Access Compliance Report

Public Rights-of-Way

(Curb Ramps)

Intersection ID: 10035681	Main Street: RED_RUST_LN	Cross Street: N/A	Location:	N
ADA ID: 7357BCEC254E	Ramp Type: PerpDiag	Initial Pass/Fail: Fail	Overall Compliance: No	Severity Score: 12.5
Codes/Mitigation Info/Possible Solution		Field Measurements/Component Compliance

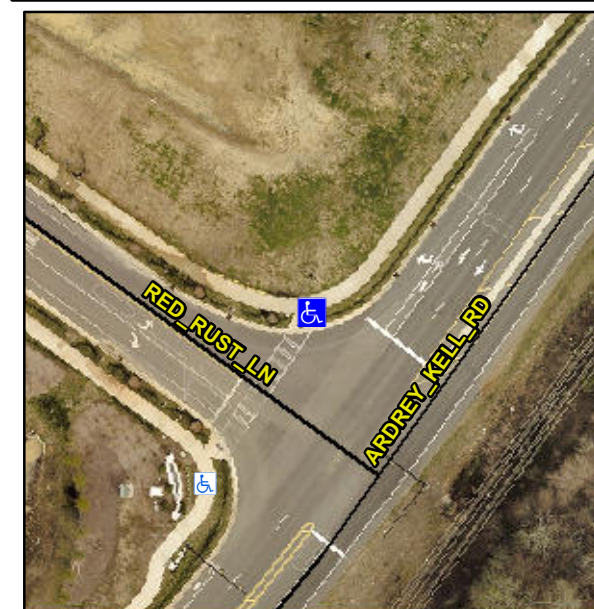
Not Found, R304.5.3

Compliance	Description	Data	Compliance	Description	Data
N/A	Ramp Length (in)	92.0	Yes	Ramp Slope (%)	5.3
Yes	Ramp Width (in)	59.5	No	Ramp XSlope (%)	6.8
N/A	Flare Type LT	N/A	N/A	Flare Type RT	N/A
N/A	Flare Slope LT (%)	N/A	N/A	Flare Slope RT (%)	N/A
N/A	Flare Traversable LT?	N/A	N/A	Flare Traversable RT?	N/A
N/A	Landing Length (in)	N/A	N/A	DWS Provided?	N/A
N/A	Landing Width (in)	N/A	N/A	DWS Contrast?	N/A
N/A	Landing Slope (%)	N/A	N/A	DWS Length (in)	N/A
N/A	Landing X Slope (%)	N/A	N/A	DWS Full Width?	N/A
N/A	Landing Curb? (Y/N)	N/A	N/A	DWS Offset (in)	N/A
N/A	Shared Landing?	N/A			
N/A	Gutter Ponding?	N/A	N/A	Gutter Slope (%)	N/A
N/A	Gutter Lip Ht (in)	N/A	N/A	Gutter X Slope (%)	N/A
N/A	Painted X Walk1?	No	N/A	Painted X Walk2?	No
	X Walk 1 Direction	To SW		X Walk 2 Direction	To SE
N/A	X Walk 1 Width (in)	N/A	N/A	X Walk 2 Width (in)	N/A
	X Walk 1 Slope (%)	1.1		X Walk 2 Slope (%)	4.3
	X Walk 1 X Slope (%)	4.3		X Walk 2 X Slope (%)	0.2

Remove & Replace Curb Ramp With Two New Directional Ramps or Equivalent.
